INDIANA DEPARTMENT OF TRANSPORTATION

STANDARDS COMMITTEE MEETING

December 18, 2008 Standards Committee Meeting

RE: Minutes for the December 18, 2008 Standards Committee Meeting

DRAWING NO. E 802-SBTS-01
OCTOBER 2008

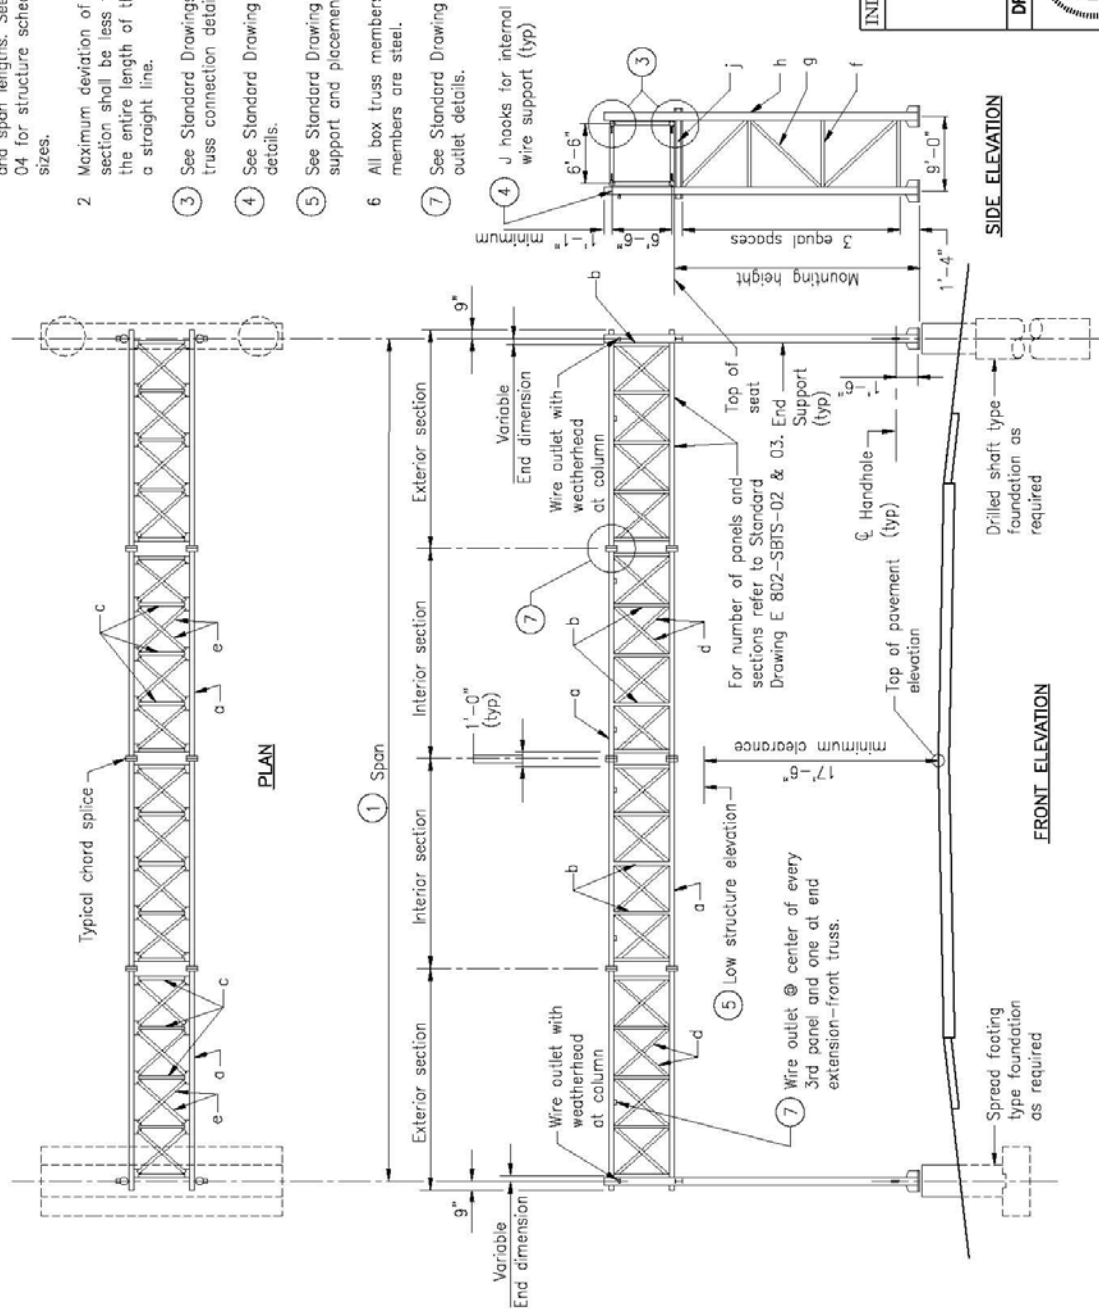
PROBLEM(S) ENCOUNTERED: Box Truss Standards need to be updated to conform to 2008 AASHTO fatigue design changes.

PROPOSED SOLUTION: Revise Standard Drawings for Box Trusses
